# UNITED STATES PATENT AND TRADEMARK OFFICE

This is a non-final Office Action for application number 10/812,221 Rod Hanger Adapter, filed on 3/29/04. Claims 1,3,7-9,13 and 15-17 are pending. The text of those sections of Title 35, U.S. Code not included in this action can be found in a prior Office action.

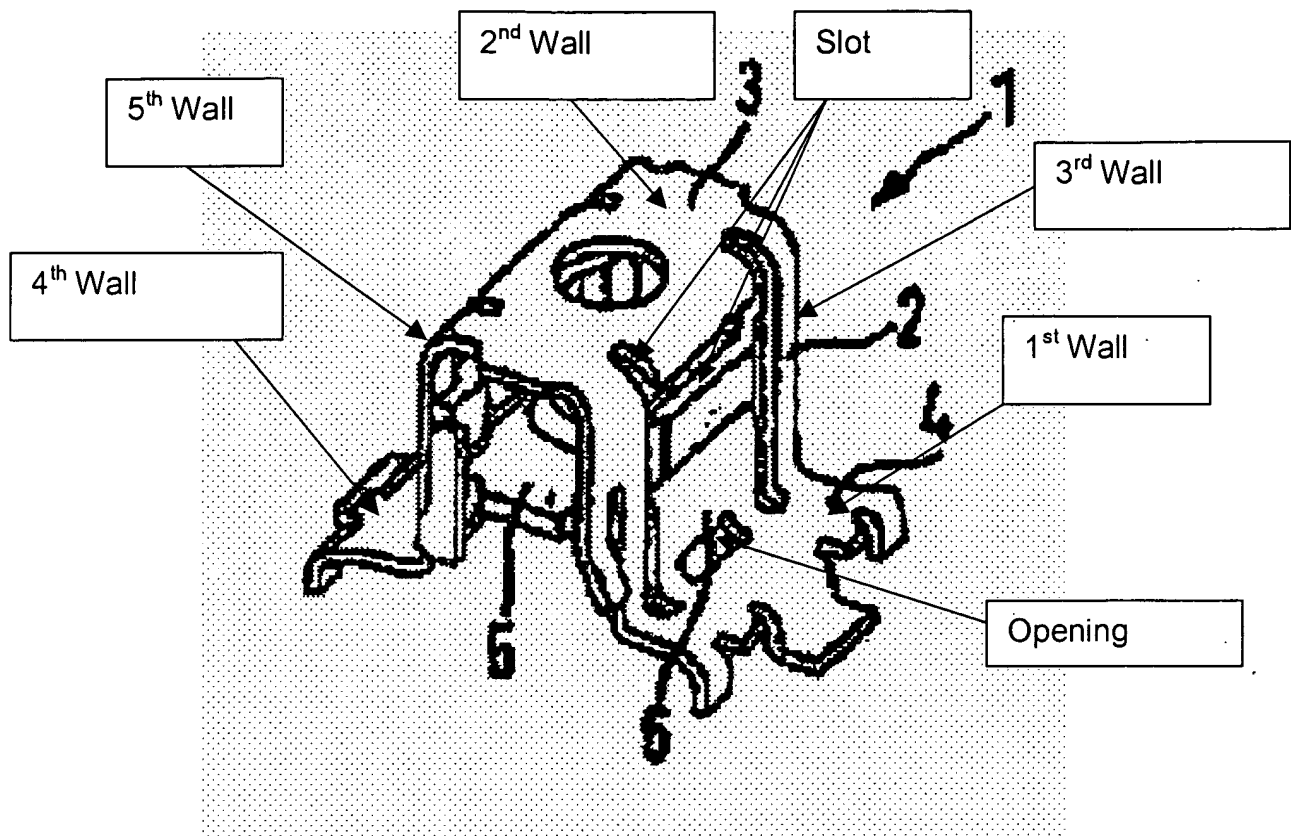
Hullman et al. teaches a device having a first wall (4) having an opening (See Drawing Below) being substantially square shaped and having an upper linear edge and being intersected by a longitudinal axis of the rod hanger adapter, a second wall (3) spaced from and at least substantially parallel and connected to the first wall, wherein the second wall includes first portion of a slot (See Drawing Below) being aligned with and intersected with the longitudinal axis of the rod hanger adapter, with a lower rounded edge, and a third wall (2) connecting the first wall (4) to the second wall (3), the third wall (2) which is substantially perpendicular to the first (4) and second walls (3) wherein a second portion of the slot is formed in the second wall extends into the third wall (2) and is aligned and intersected with by the longitudinal axis, and a fourth wall (See Drawing Below) having a notch (15) formed on a lower edge of the fourth wall, with an upper linear edge, the fourth wall which is spaced from and substantially parallel to the second wall and a fifth wall connecting the second and fourth walls. Hullman et al. also discloses wherein a longitudinal axis of the opening is aligned with a longitudinal axis of the slot, and the longitudinal axis of the notch is aligned with a longitudinal axis of the opening.

The applicant also argues that the notches are offset from the opening and is not aligned with the opening. This is unpersuasive in that portions of the opening and portions of the notch are aligned.
